Attachment A. Interference Analysis of MDSA Transmitter

Northpoint conducted a comprehensive analysis of the MDSA proposed transmitter. The analysis reveals that a large population would be subject to harmful interference from the MDSA proposed experiment. The analysis also reveals that the PFD contours MDSA has submitted in no manner reflect the actual PFD contours that would result from an antenna of the type MDSA presents in its application.

Figure 1. MDS Power Flux Density

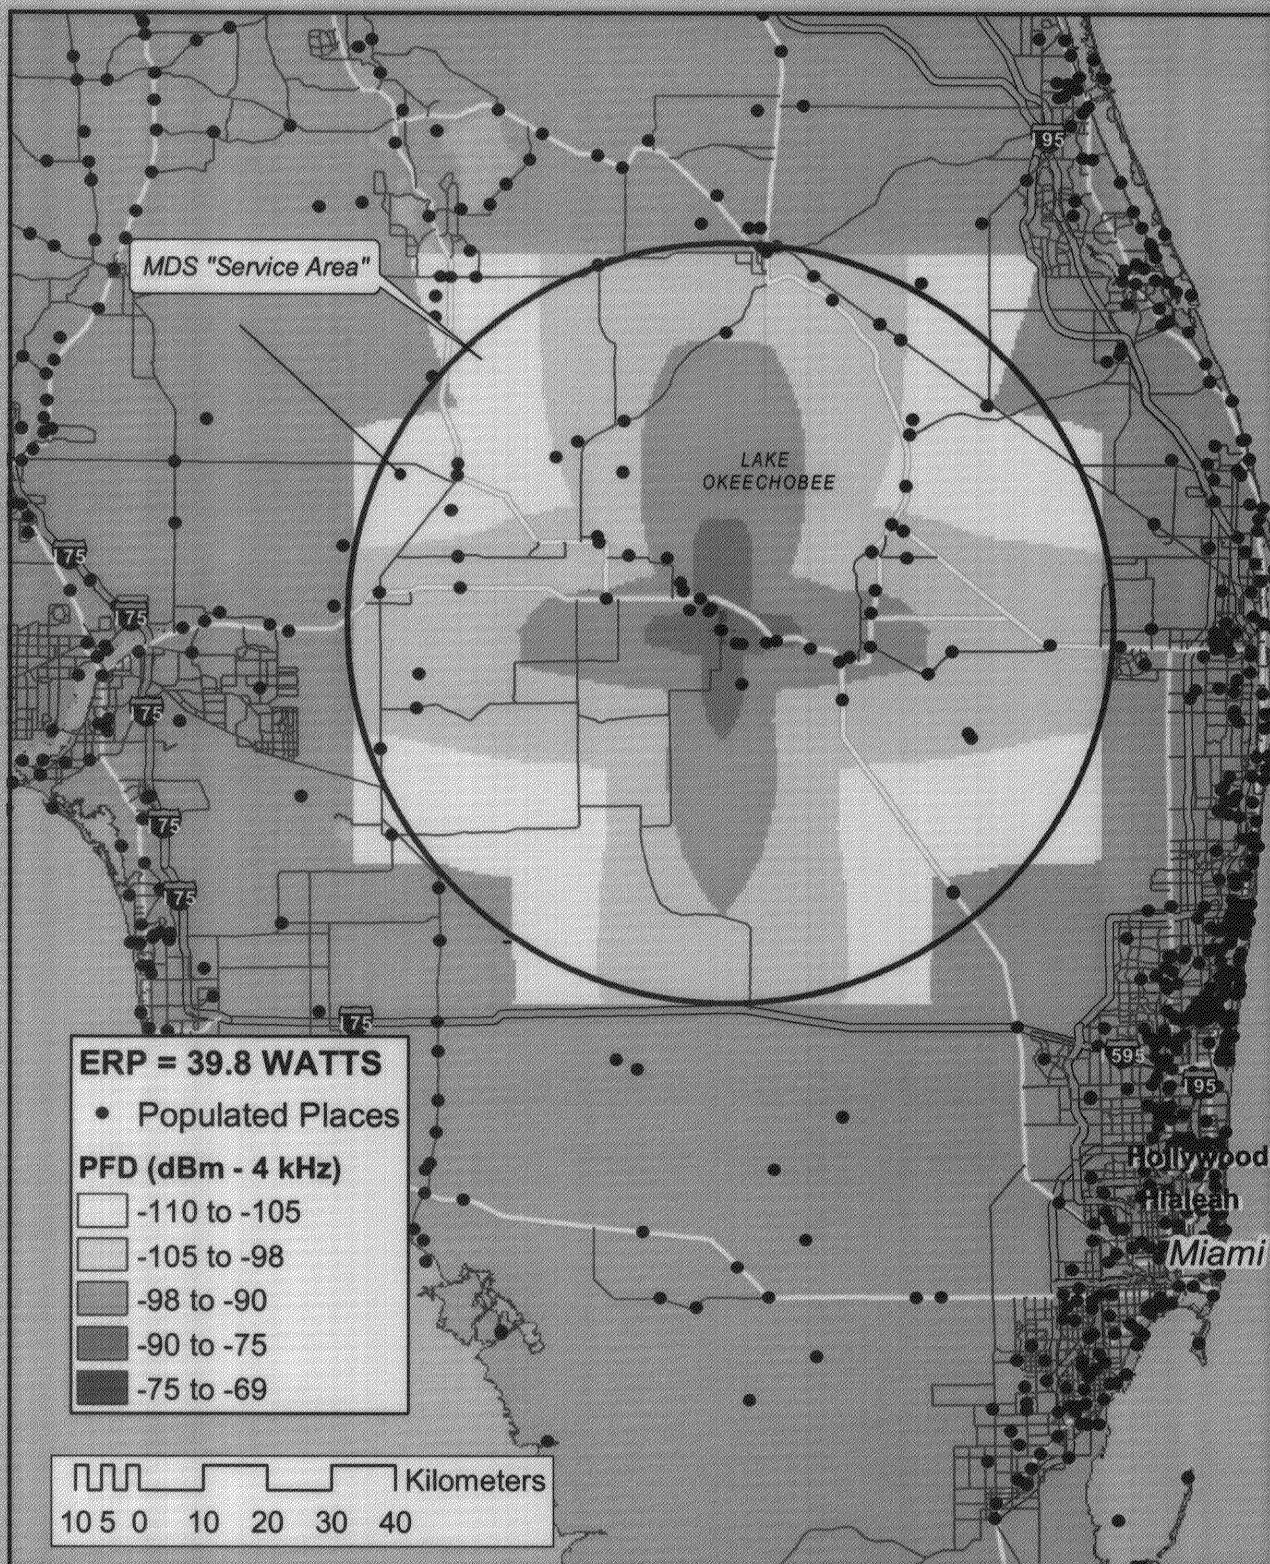
MDSA presented a series of round PFD contours in its supplement, but the MDSA antenna has variable gain with azimuth, up to 12 dB; therefore the actual PFD contours are not round, but clover-shaped. Moreover, MDSA did not identify the bandwidth associated with its PFD contours, but in any case, as the following table illustrates, MDSA's contours cannot be rectified with free space propagation.

Figure 1 shows the actual PFD contours of the MDSA antenna described in the supplement.

Figure 2. MDS Would Exceed EPFD Levels Over a Huge Populated Area

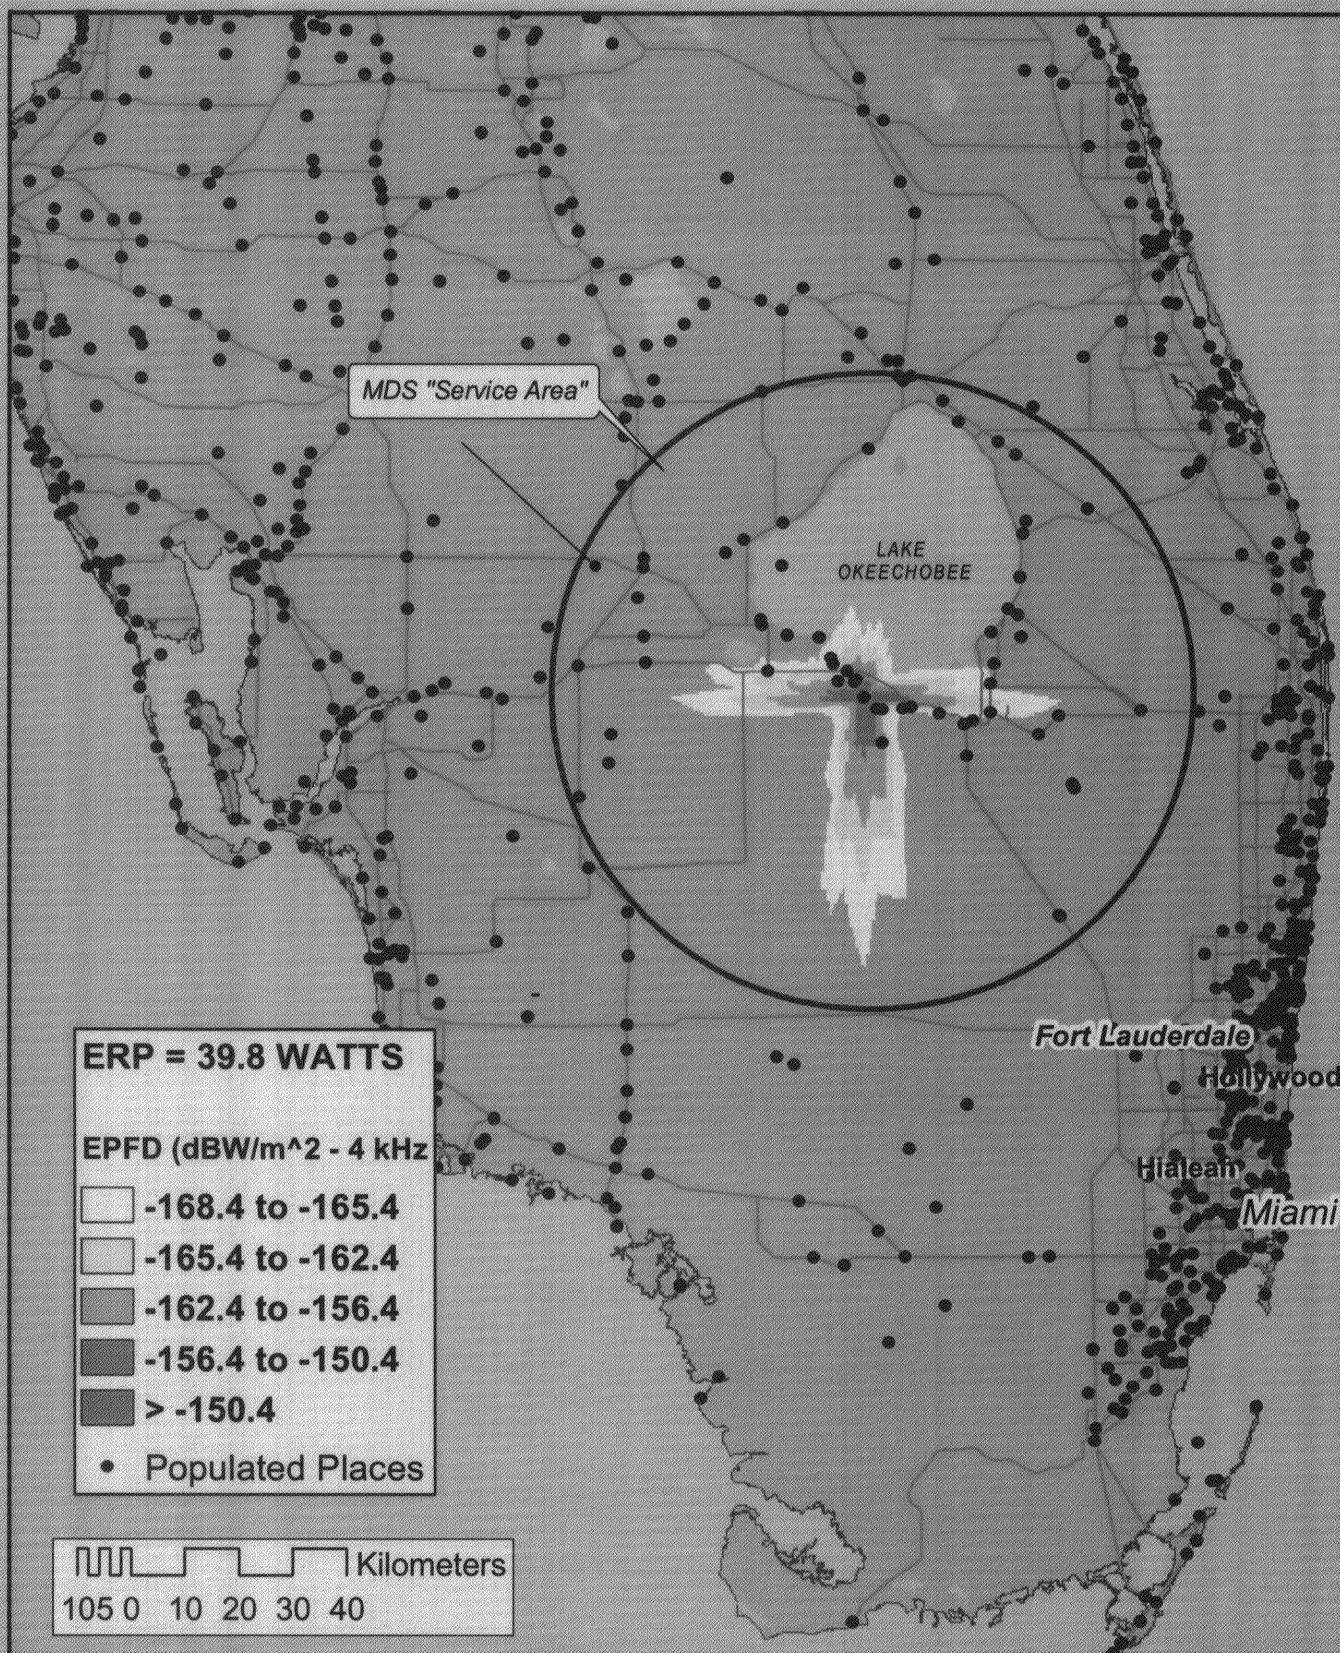
Figure 2 shows the allowable EPFD of -168 dBW/m² – 4kHz would be exceeded in a large, populated portion of the MDSA proposed “service area”.

From these figures it is clear the MDS proposed experiment certainly would exceed the FCC EPFD contours for a large populated area and would cause harmful interference to any unprotected DBS operation. The analysis shows that more than ten thousand of residents of Clewiston, Florida and the surrounding area would be within the EPFD contours, as shown in the following table. Over 3,000 persons would be within the contour where the EPFD is exceeded by over 12 dB.

Figure 3. MDS Transmissions Likely to Cause Outage in Clear Air for Highly Populated Area

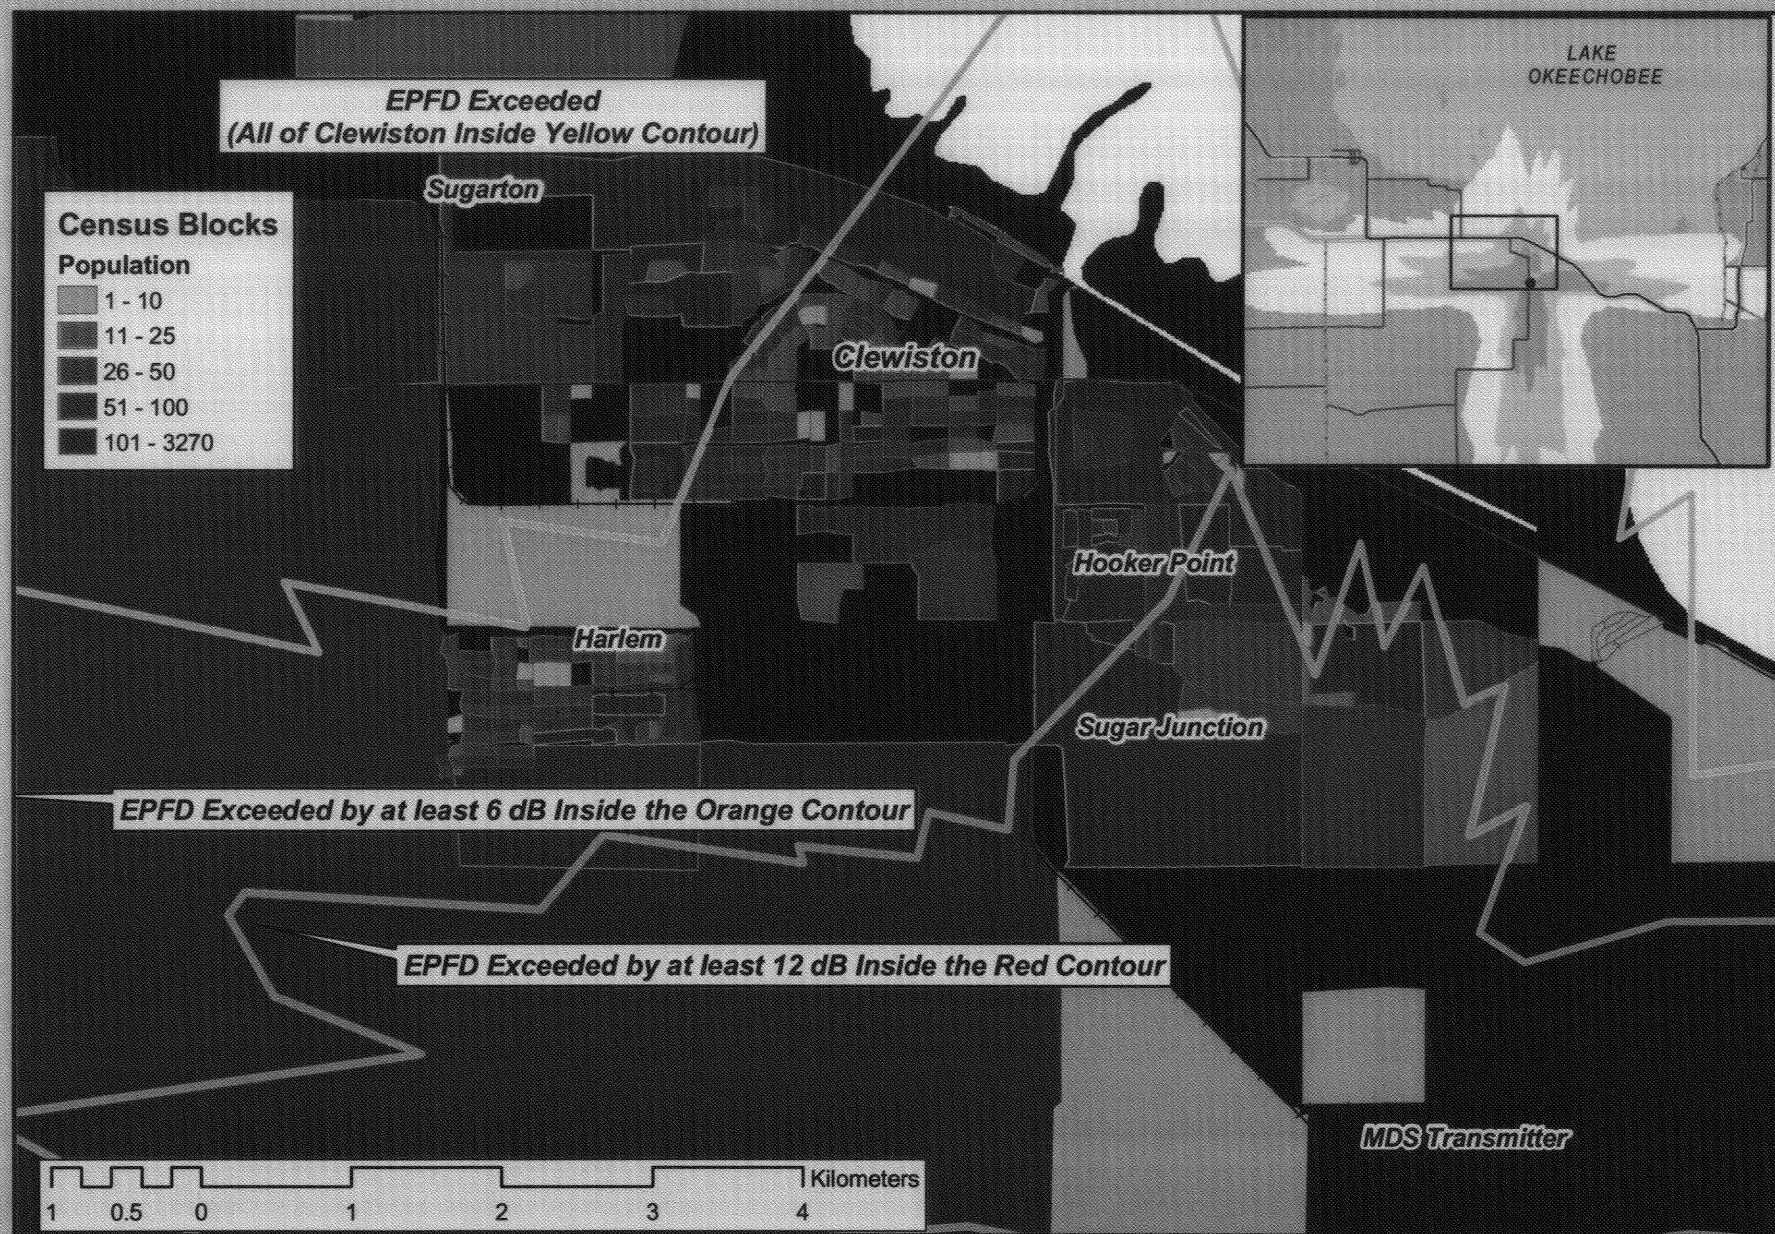
Figure 3 shows the area near Clewiston where the EPFD would be exceeded, along with the year 2000 Census blocks.
